SERVICE DIRECTIVE BULLETIN

SERVICE DIRECTIVE BULLETIN NO. 0093

1. SUBJECT: Tail Rotor Control Cable Inspection
2. MODEL: F-28A, F-28C(-2), F-28F, 280, 280C, 280F, and 280FX
3. EFFECTIVITY: All serial numbers equipped with tail rotor control cable pulleys installed in the tailcone (Refer to paragraph 4)
4. BACKGROUND:

Figure 1. Tail Rotor Control Cable Pulley Installation

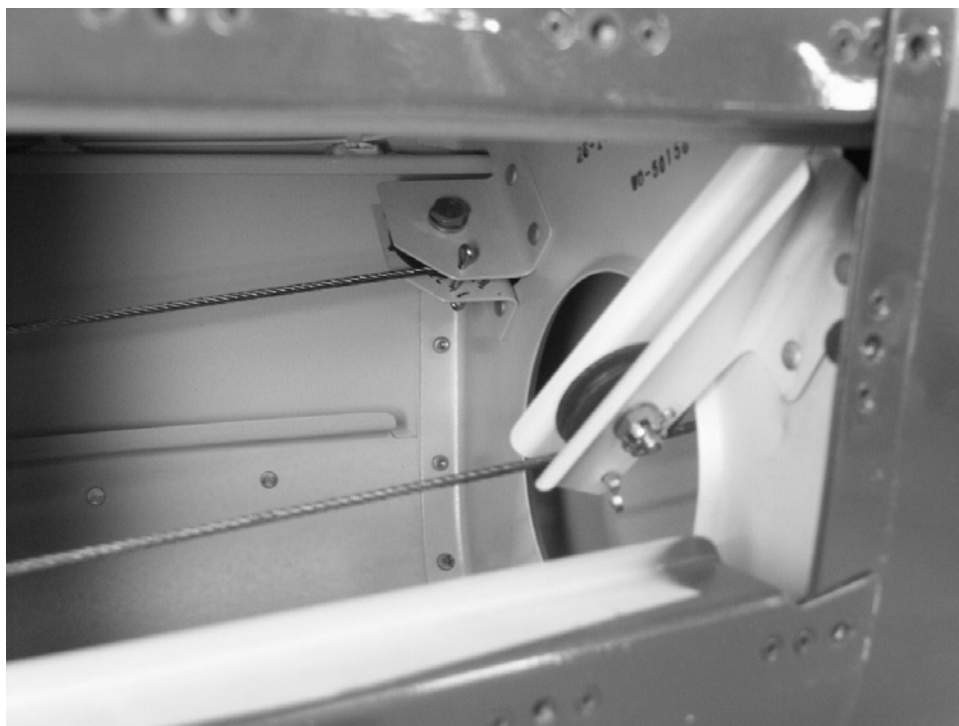
Enstrom has received reports from inspection personnel in the field of frayed and worn tail rotor control cables. The reports indicate that the wear is occurring at the pulleys (See Figure 1) in the tailcone located aft of the horizontal stabilizers. These pulleys are installed in tailcone assemblies installed on all 280FX model aircraft and F-28F model aircraft, S/N 744 and subsequent.

Figure 1 shows the latest tail rotor control cable pulley installation. On earlier installations, the left side pulley installation is a mirror image of the right side pulley installation.

4. Partially pull the tail rotor control cables out of the tailcone through the access opening and inspect the areas of the tail rotor control cables that pass over the pulleys and inspect the pulleys in accordance with FAA Advisory Circular 43.13-1B, paragraph 7-149, Cable System Inspection (Appendix A to this Service Directive Bulletin). If the pulleys are rubbing on the mounting brackets, AN960-10L Washers may be used as shims to eliminate the interference.

Figure 2. Access Panel Location

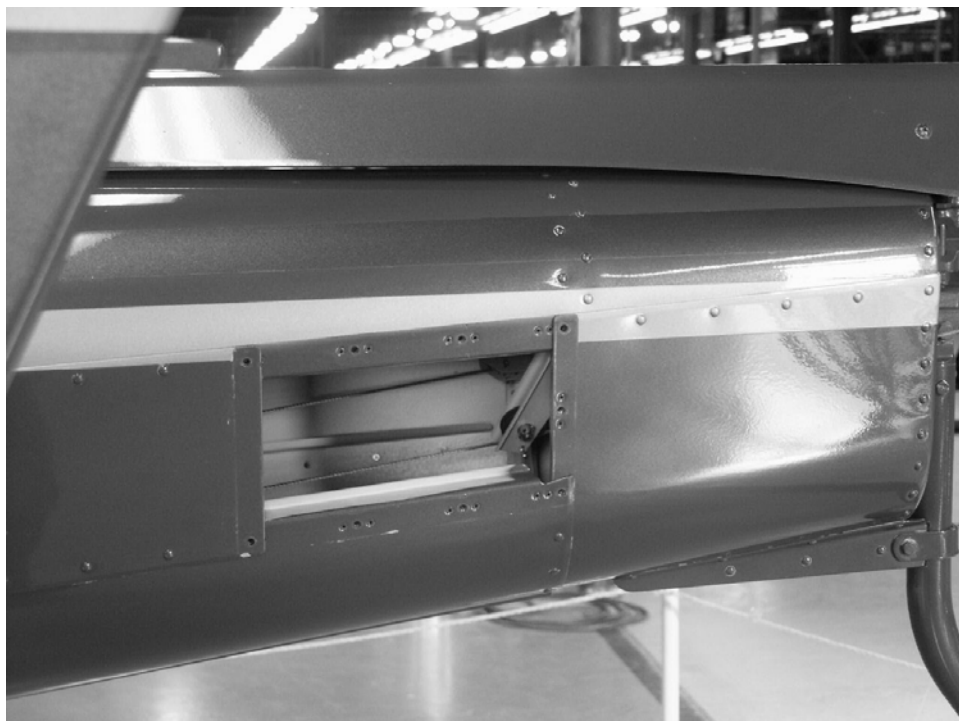
1. Remove the access panel located aft of the horizontal stabilizer on the left side of the tailcone (See Figure 2) and determine if the tailcone is equipped with the pulleys.
